**AGENDA
HISTORIC DISTRICT COUNCIL
REGULAR MEETING
OCTOBER 17, 2019
5:00 PM
CITY HALL COMMISSION CHAMBERS
204 ASH STREET
FERNANDINA BEACH, FL 32034**

- 1. CALL TO ORDER / ROLL CALL / DETERMINATION OF QUORUM**
- 2. APPROVAL OF MEETING MINUTES**
- 3. OLD BUSINESS**
 - 3.1 HDC 2019-01: COTNER ASSOCIATES, INC. ARCHITECTS, AGENT FOR JAMES D. & CONSTANCE N. SCOTT, 123 S. 7TH STREET**
Amendment to Certificate of Approval (COA) to allow for the addition of a window. *(Quasi-Judicial)*

- 4.2 HDC 2019-35 WAYNE R. CHISM, AGENT FOR PETER GRASSI / TUP REAL ESTATE HOLDINGS LLC, 14 N. 2ND STREET**
Certificate of Approval (COA) to construct a three story mixed use primary structure. *(Quasi-Judicial)*

1st LEVEL FRAMING & ELECTRICAL PLAN B4.0

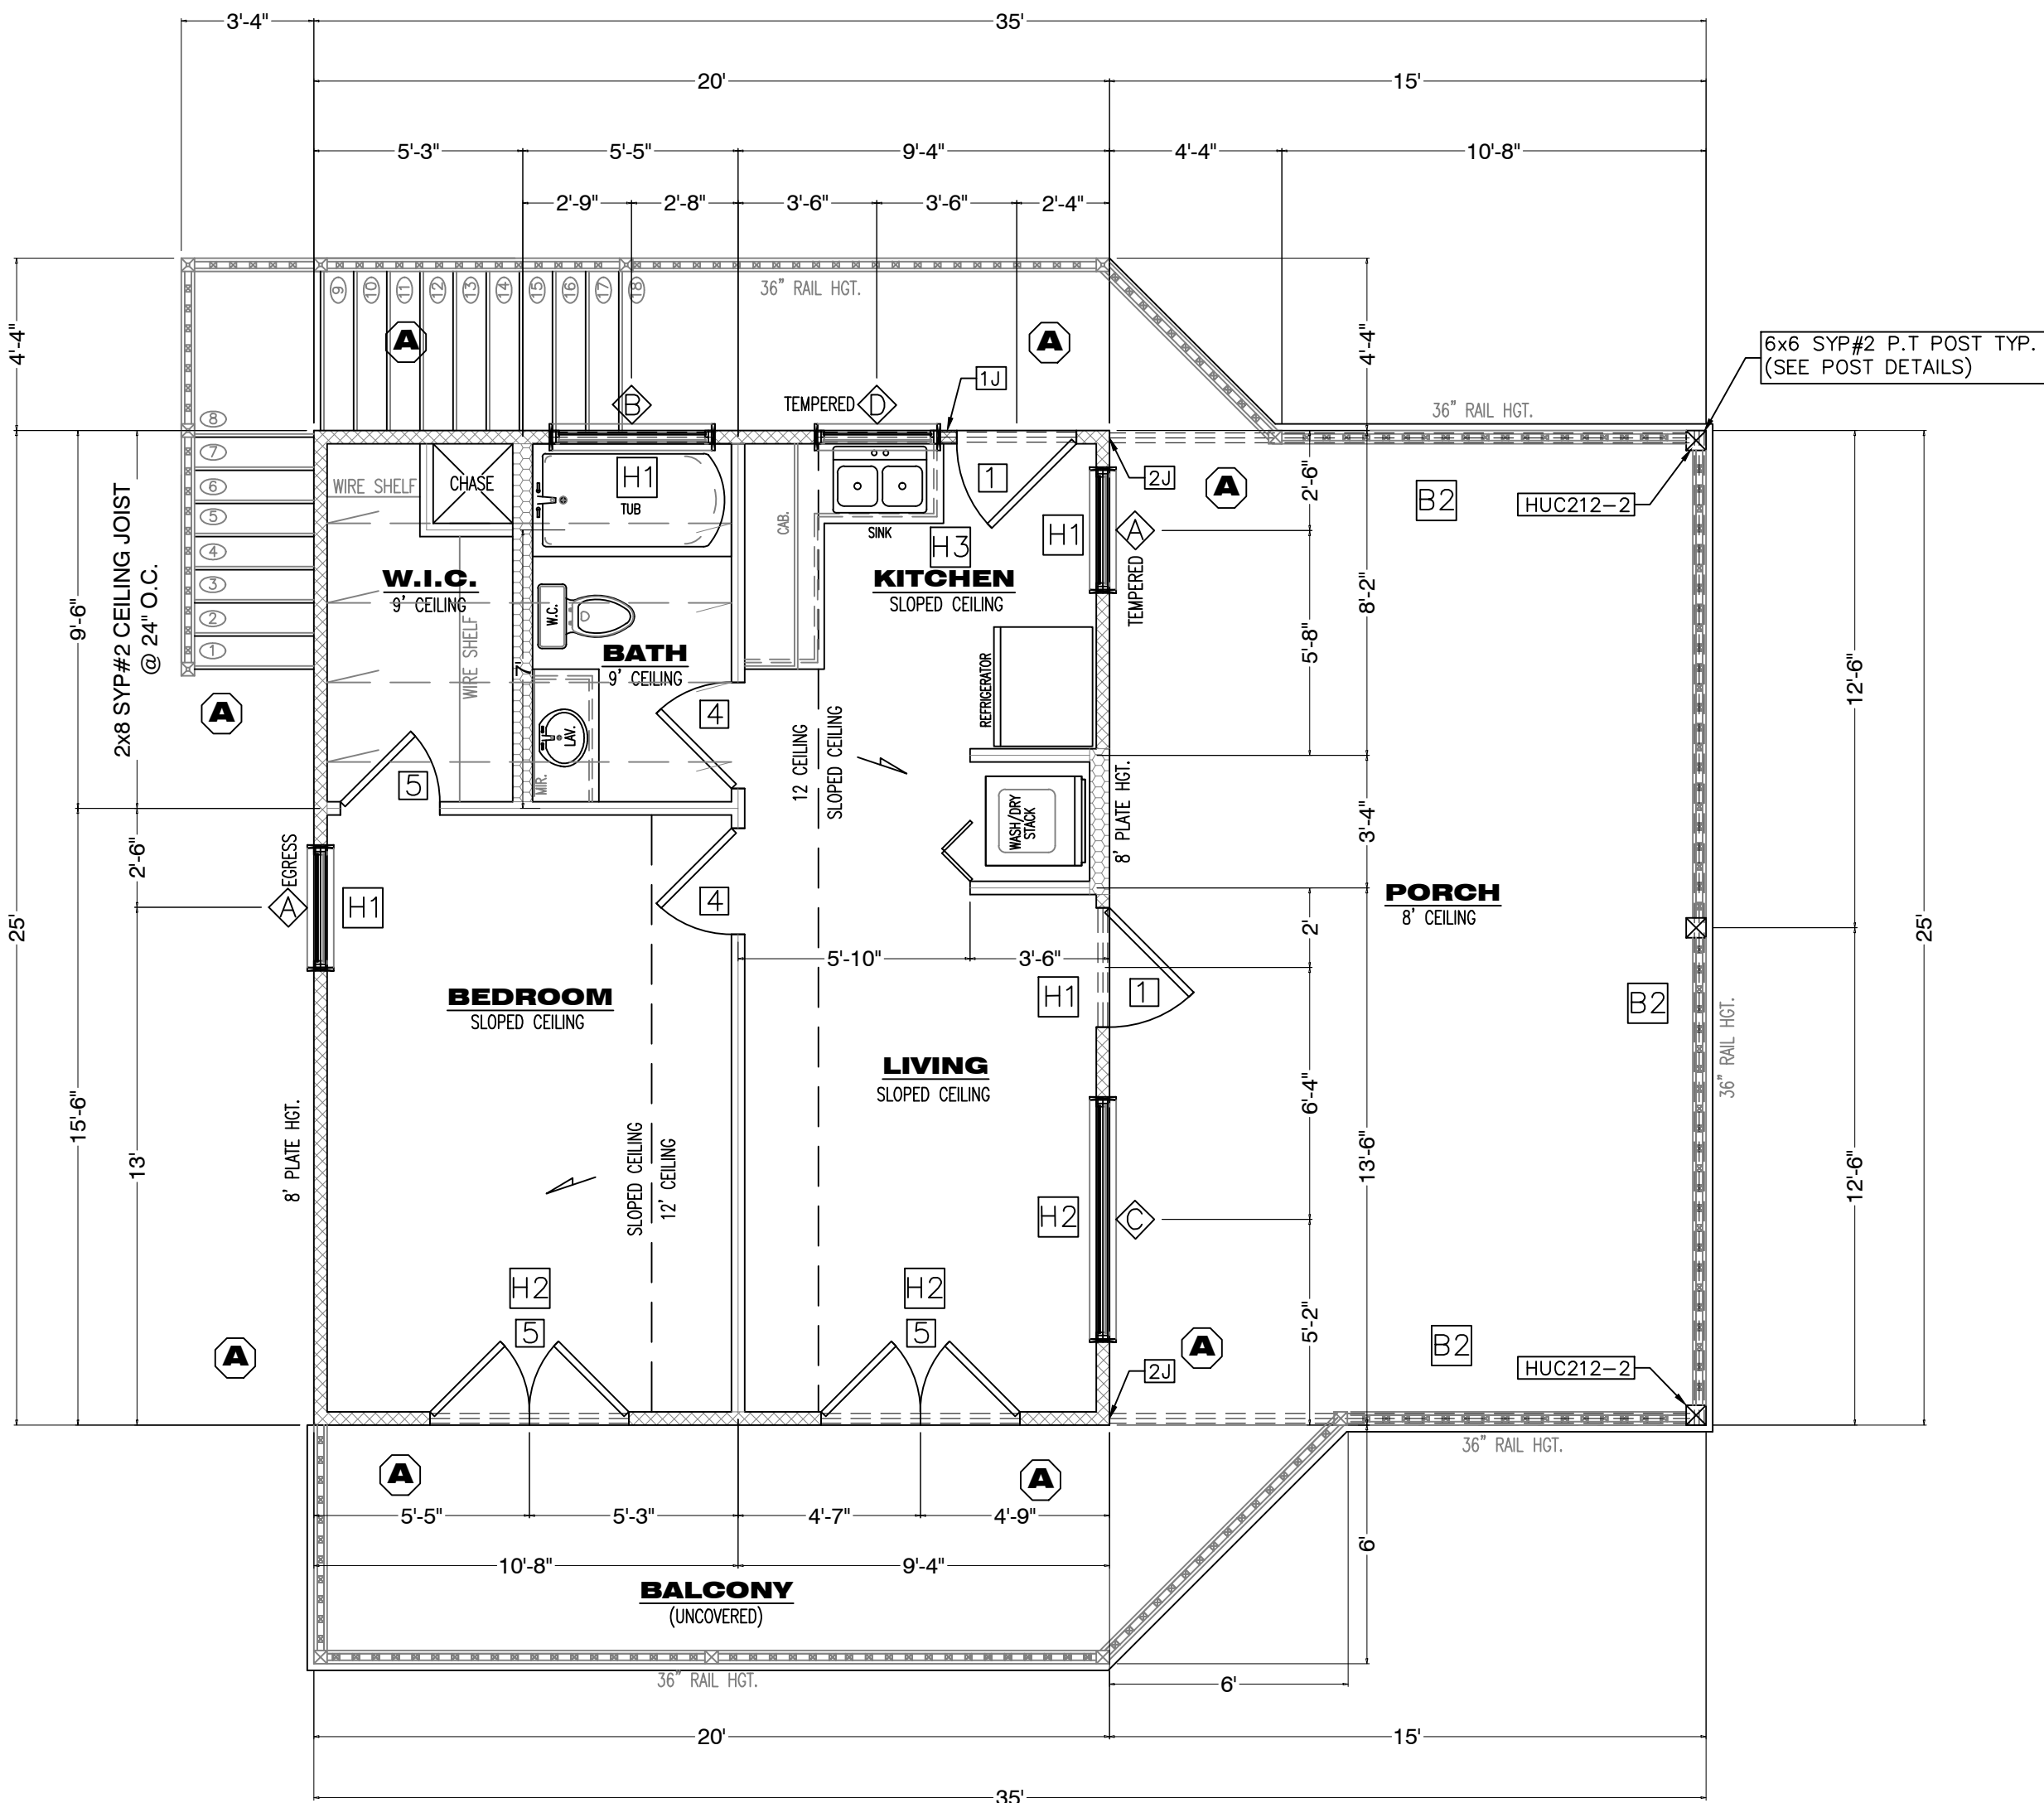
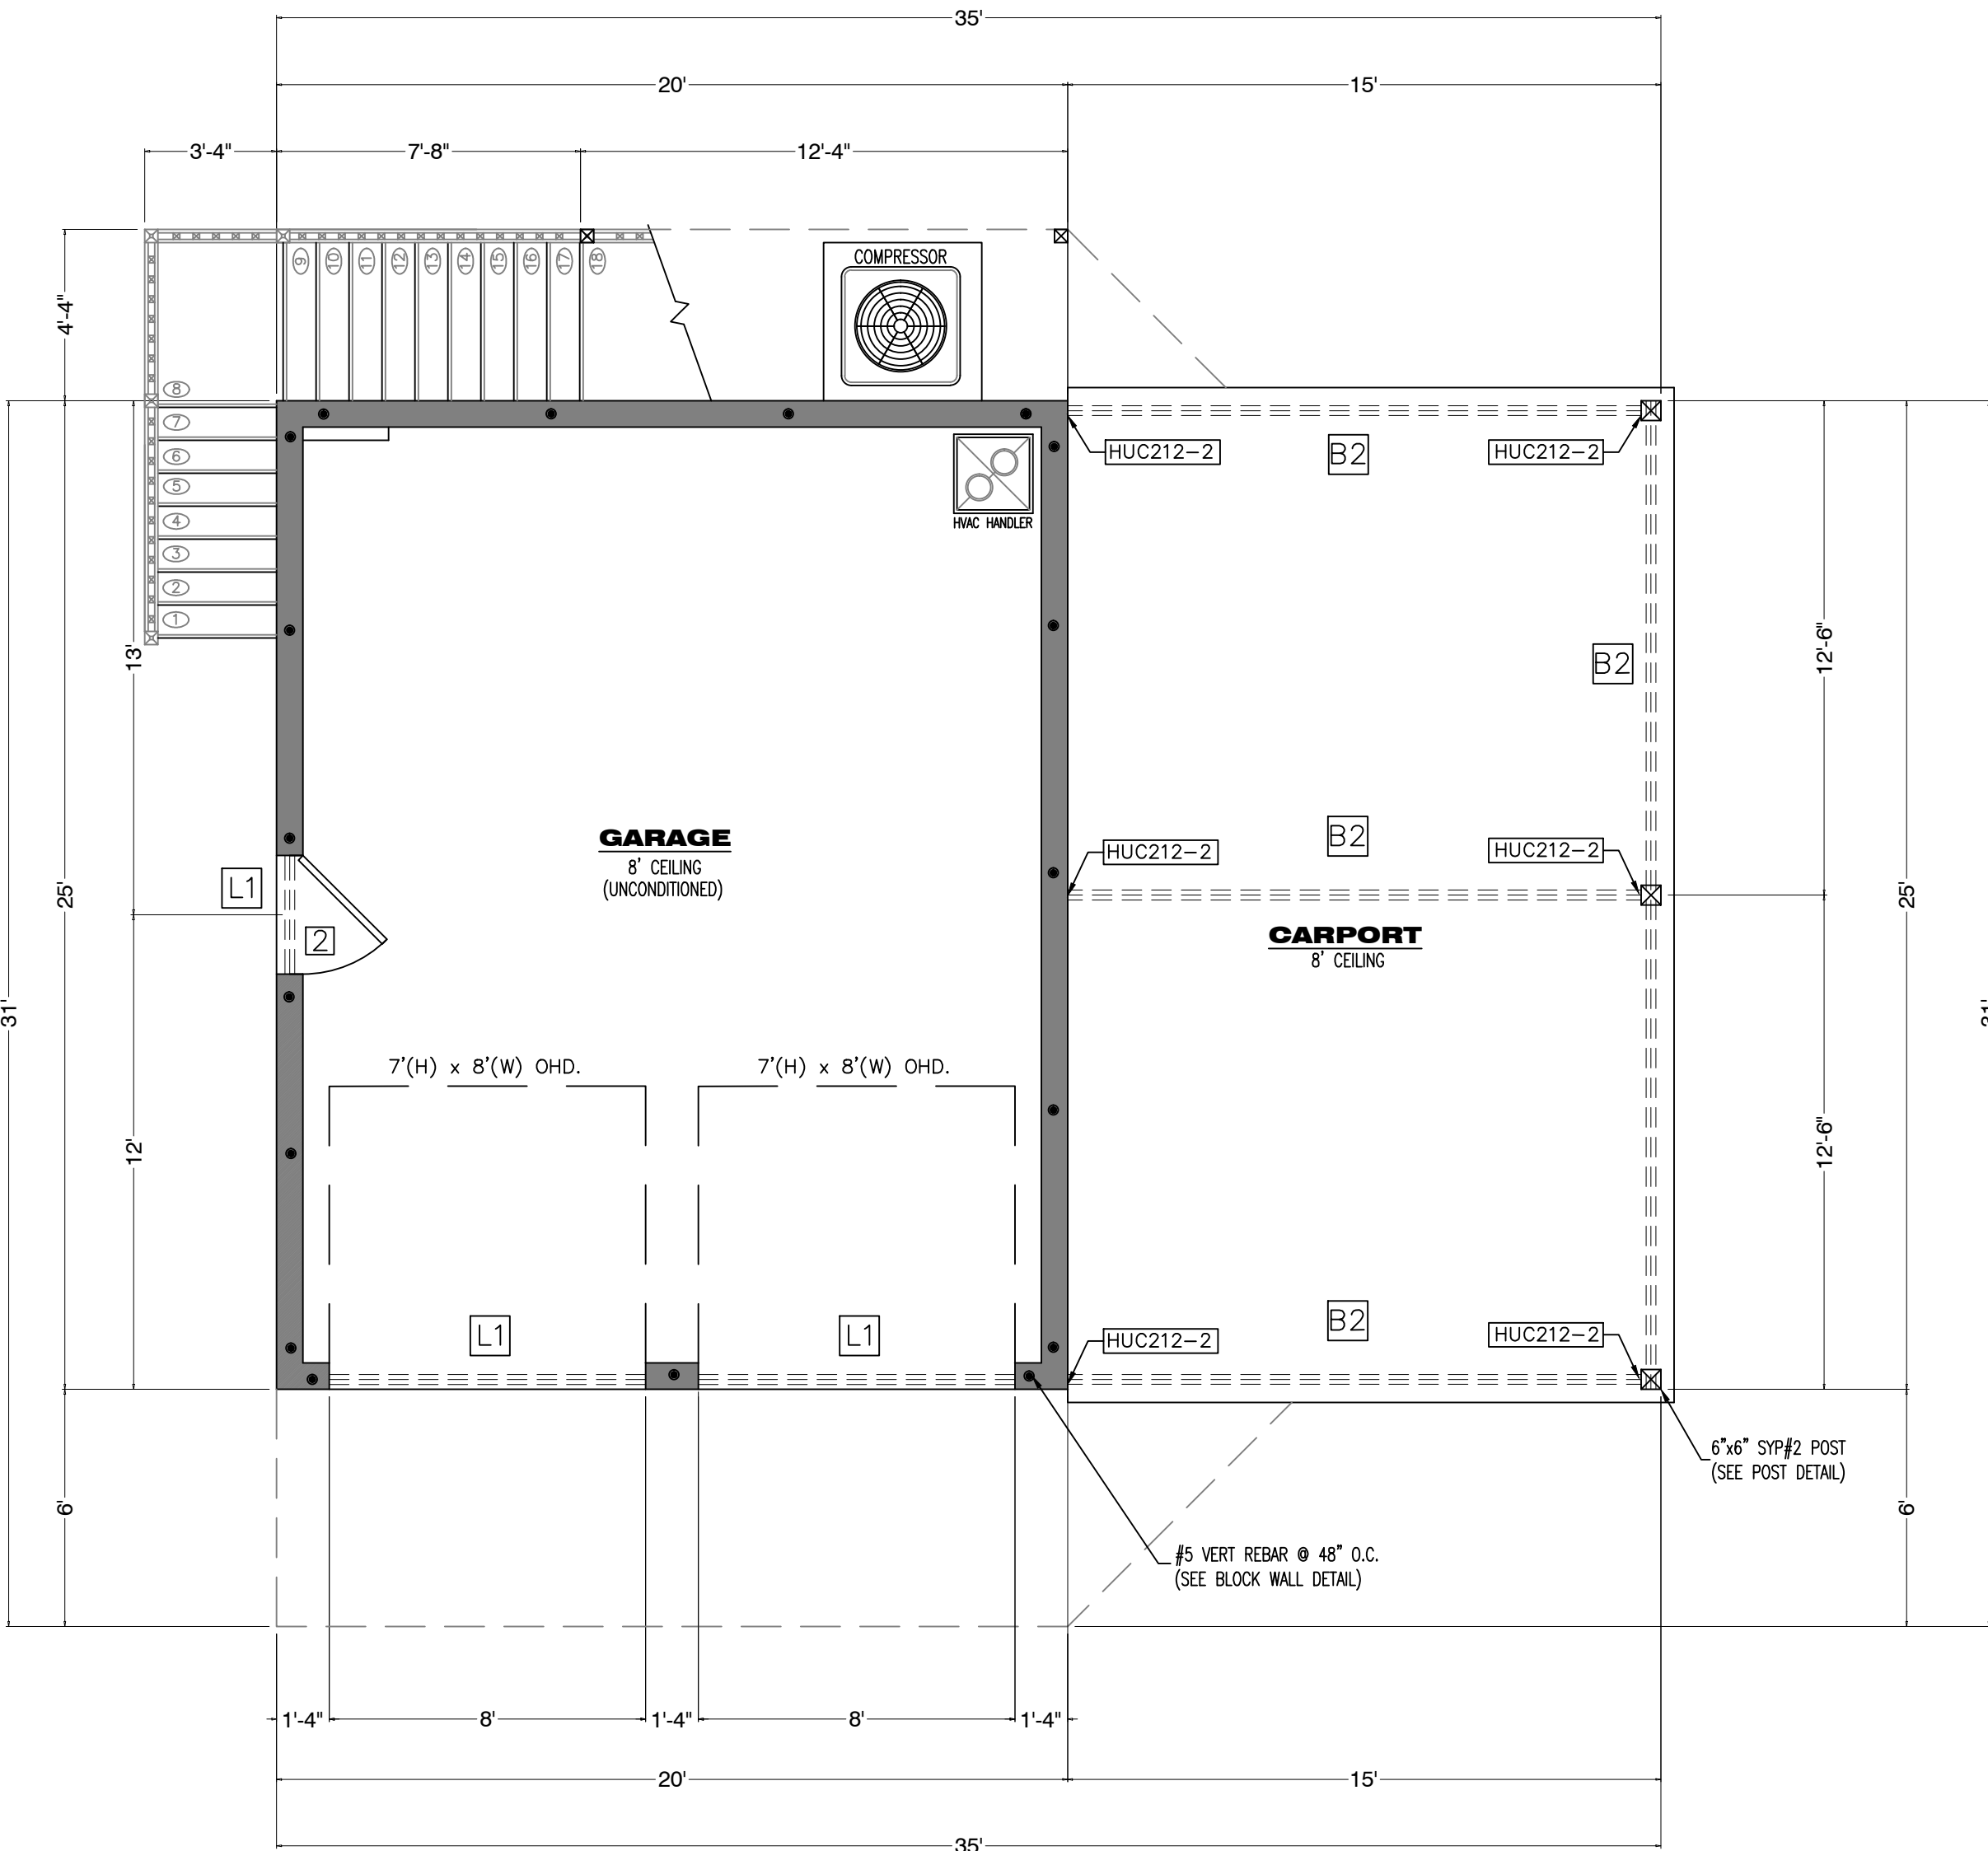
- **Total Square Footage** – There is an inconsistency in the proposed plans related to square footage of the accessory dwelling unit. The chart on sheet B4.0 indicates that the second floor has a sq. footage of 510 sq. feet. It is believed that this is an error that was not corrected from an earlier version that had a bump out that was removed from this final version. The applicant will be asked to verify that the total square footage of the buildings footprint does not exceed 500 square feet.

BISTRO 2020
14 NORTH SECOND STREET

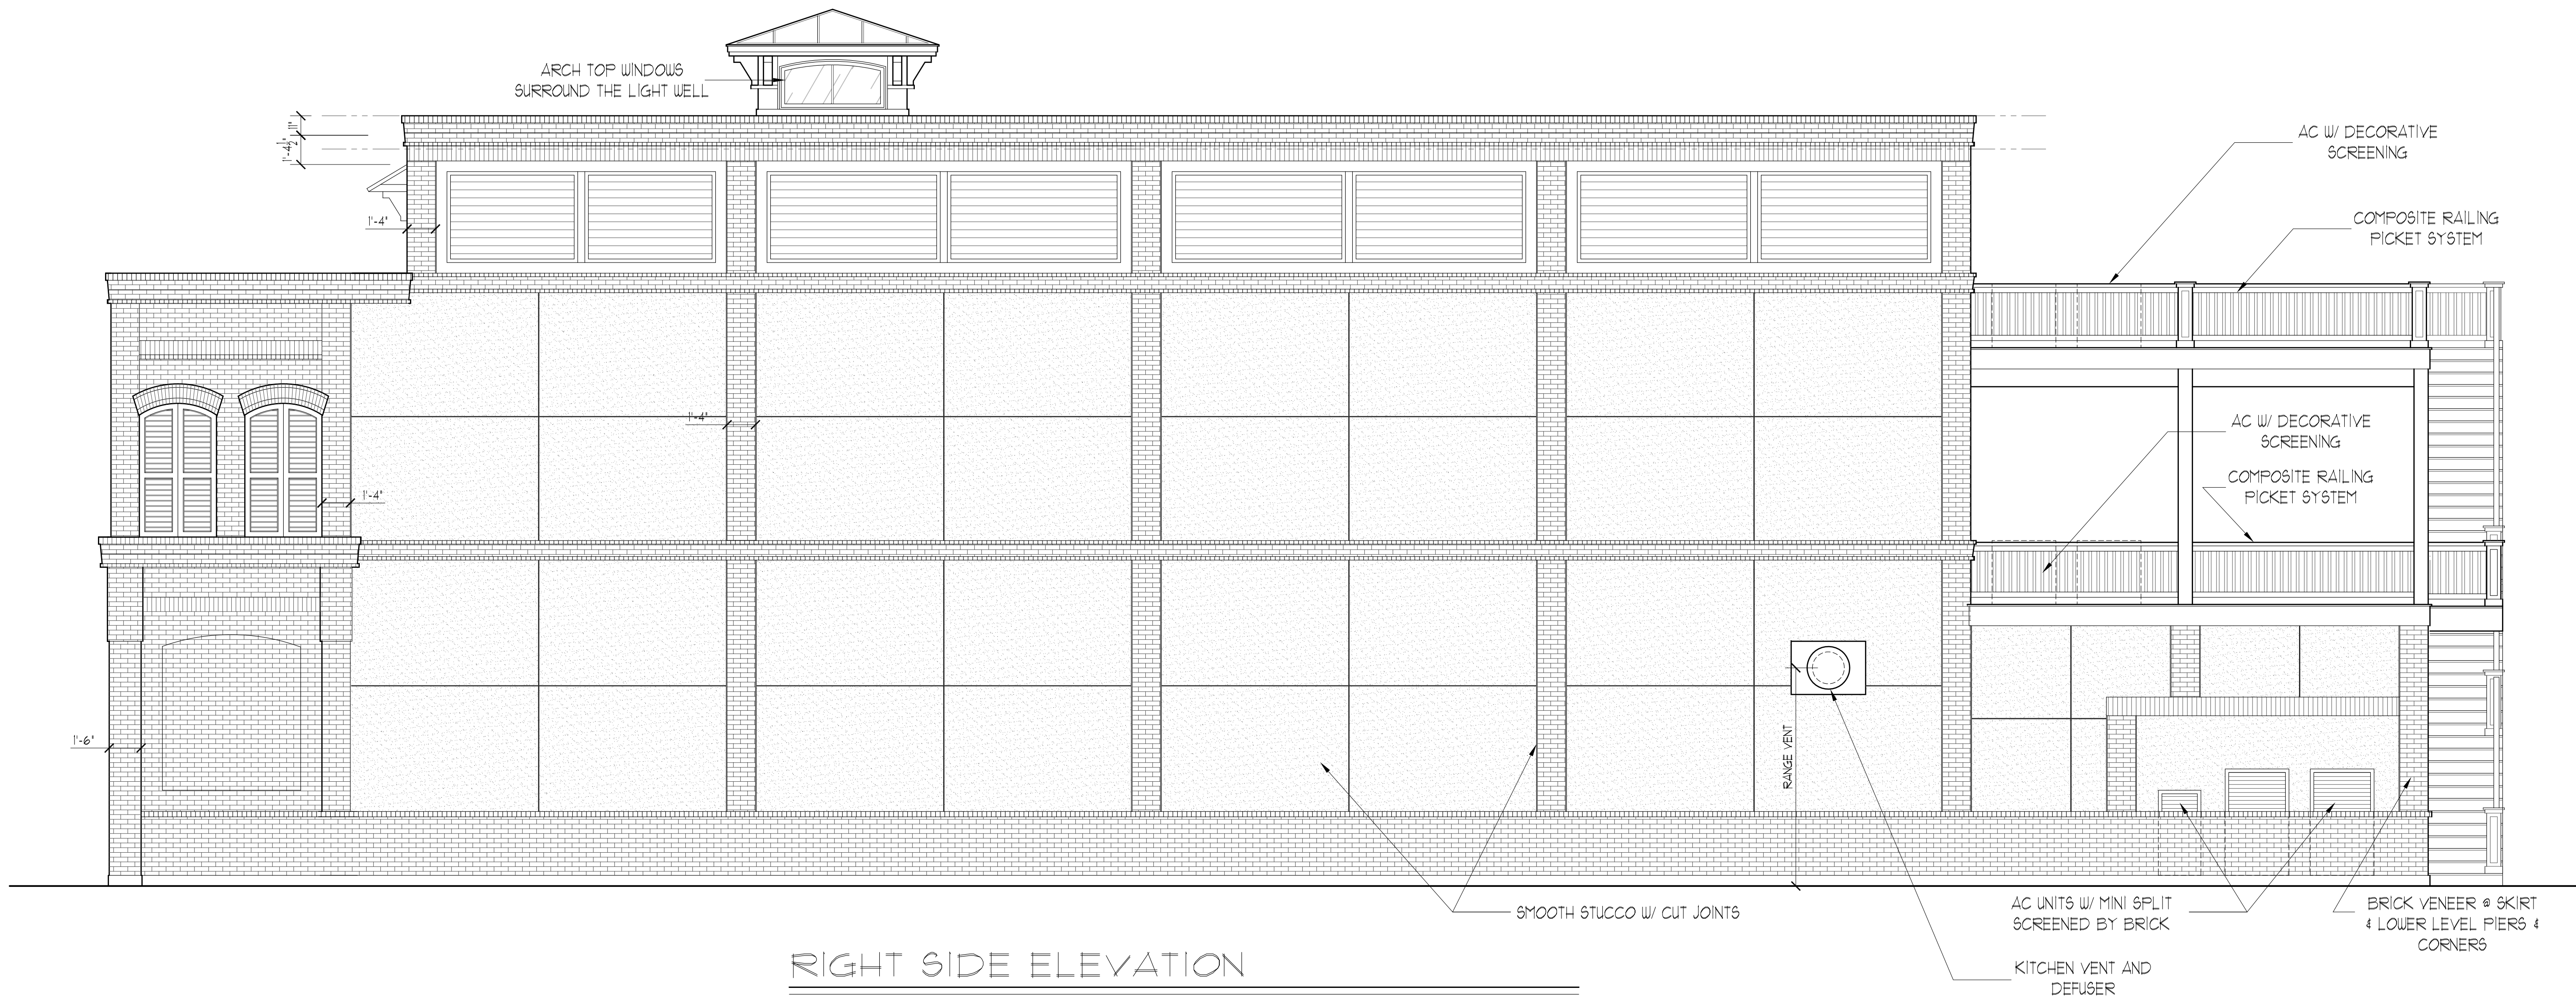
On sheet A-2, the applicant has provided a calculation of building heights with numbers that do not match the streetscape elevation heights on sheet A-1. The board will need further clarification to consider this as evidence. Staff cannot make a recommendation of final approval until it is clear that the proposed structure is within the guidelines for compatible heights. Staff recommends requiring a scaled streetscape elevation verified and stamped by the architect before final approval.
